An Coimisiún Pleanála,

Re: ABP case reference : 324258

Applicant : Constant Energy Limited_Tirawley wind farm

Exhibit 1 shows the Meteo blue wind rose, Exhibit 2 shows the Met Eireann wind rose for Belmullet, which are very similar.

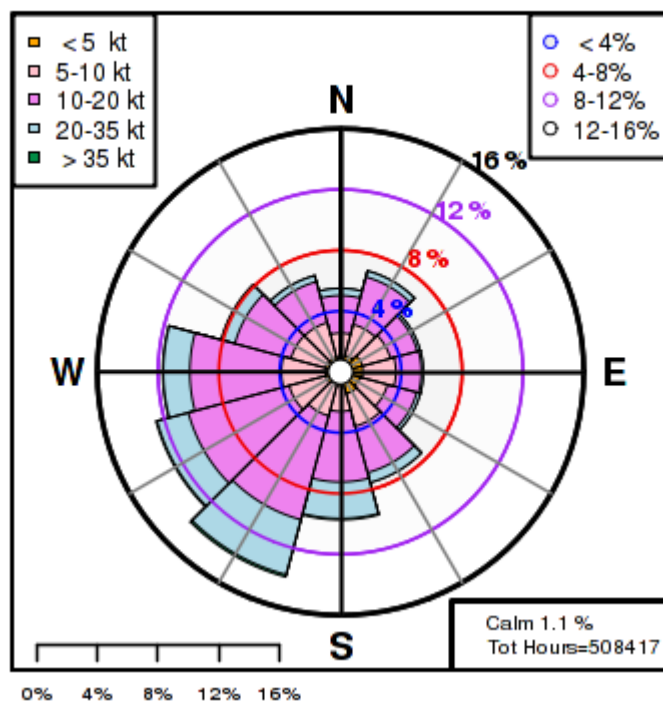
It should be noted that the prevailing winds, those requiring 7 rotor diameter separation distance between turbines, are not only from the southwest direction. Exhibit 1 shows that in reality there are strong and frequent winds from 170 deg. South South east to 300 deg. West northwest in a clockwise direction.

Exhibit 1 shows the amount of days per year the wind blows from all directions

Where I am going here is that the prevailing winds are significant from 170 deg SSE clockwise to 300 deg WNW.

This has great significance in the deciding if a pairing of wind turbines are in the prevailing wind or not, resulting in the pairing requiring 7 rotor diameters separation or 3 rotors diameter separation.

I would ask that the applicant generate a wind rose from their Mast data in order that it can be compared to the Belmullet Wind rose. The Claremorris wind rose differs little to the Belmullet wind rose so I do not expect a site specific wind rose to differ greatly.

Map 1 shows the turbine distances apart and what those distances represent in rotor diameters

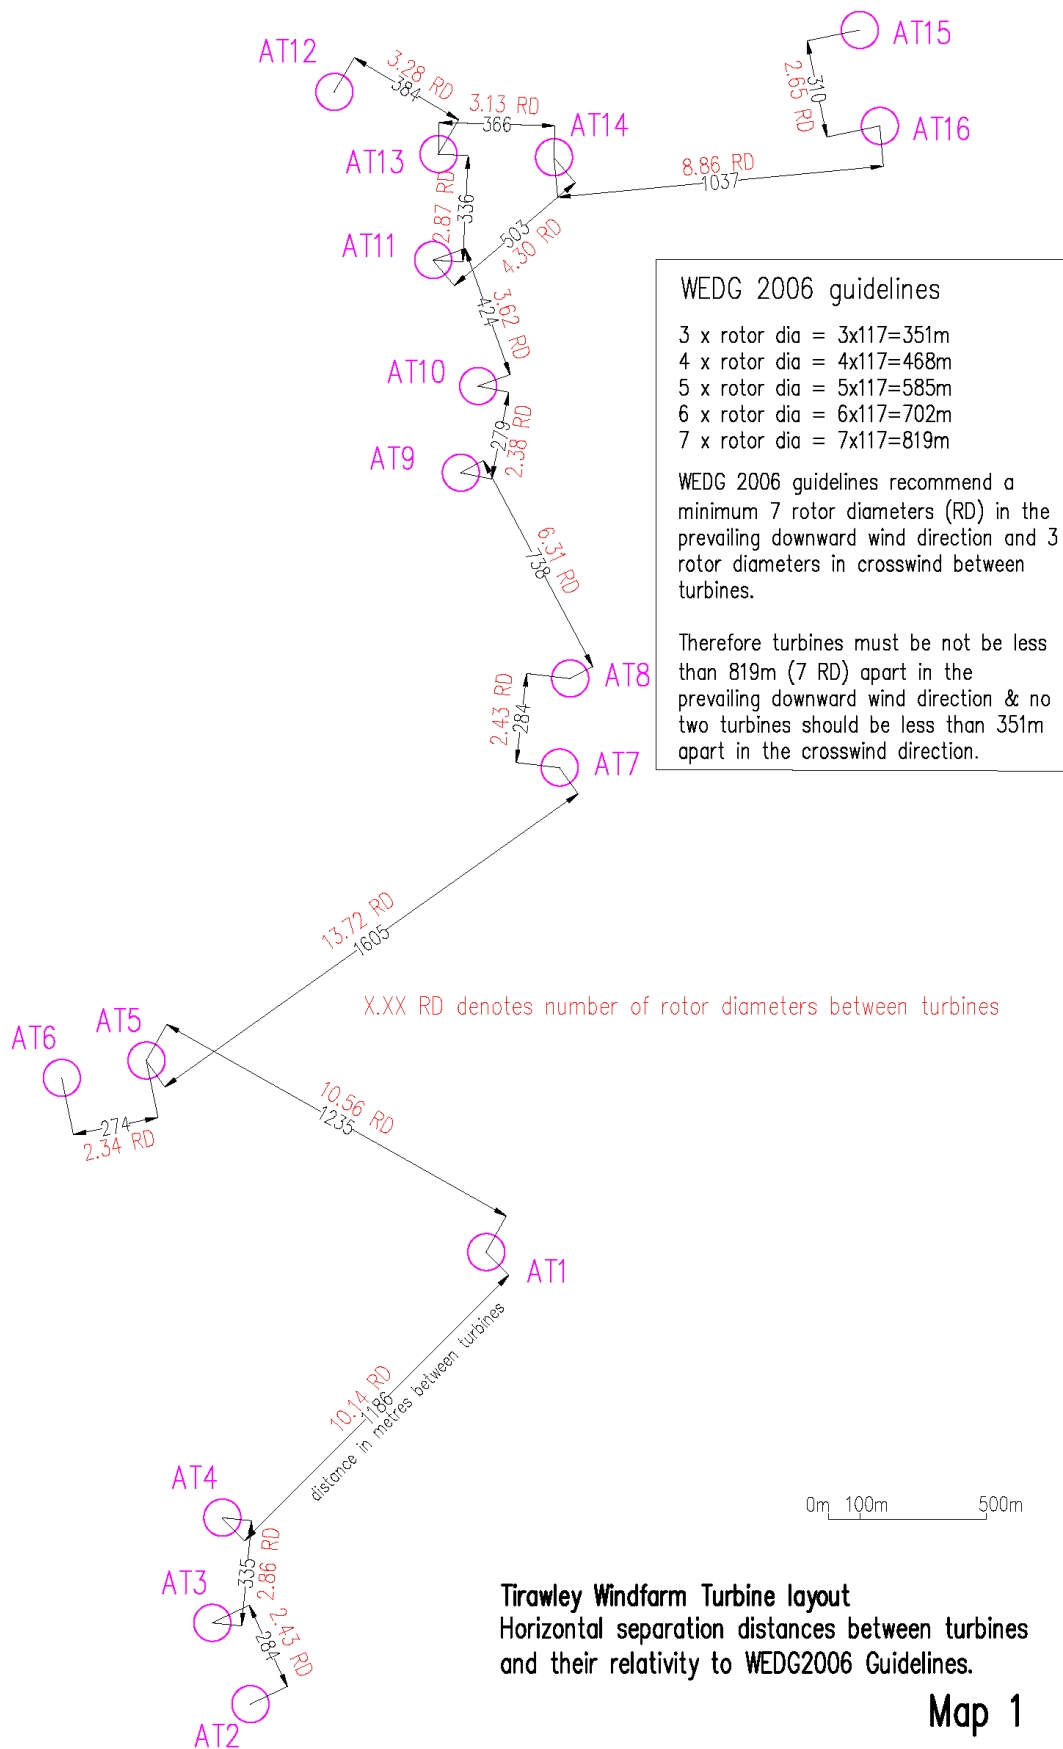
In ABP case reference **324258** to which this observation refers, the applicant has, as one can see in Map 1, next page, ignored the turbine separation distances from adjacent turbines, that are recommended in the WEDG2006 guidelines.

Outline next, turbine pairings that should have the 7 rotor diameter separation based on the wind rose and its prevailing winds per WEDG2006 requirement:

AT3 to AT4 has only 2.86 rotor diameters instead of 7 rotor diameters. 41% of required separation
AT6 to AT5 has only 2.34 rotor diameters instead of 7 rotor diameters. 33% of required separation
AT7 to AT8 has only 2.43 rotor diameters instead of 7 rotor diameters. 35% of required separation
AT9 to AT10 has only 2.38 rotor diameters instead of 7 rotor diameters. 34% of required separation
AT11 to AT13 has only 2.87 rotor diameters instead of 7 rotor diameters. 41% of required separation
AT13 to AT14 has only 3.13 rotor diameters instead of 7 rotor diameters. 45% of required separation
AT11 to AT14 has only 4.30 rotor diameters instead of 7 rotor diameters. 61 % of required separation

I would also include AT2 to AT3, AT10 to AT11, AT15 to AT16 & AT12 to AT13 in those 7 rotor diameter separation requirement as they have not a much lesser prevailing winds from the South Southeast and the West northwest directions.

What makes matters worse are combinations of these separation distances in the main prevailing wind direction.

On the basis of what I have outlined and experienced, I highly recommend the aforementioned issues be carefully considered, and the design be altered significantly.
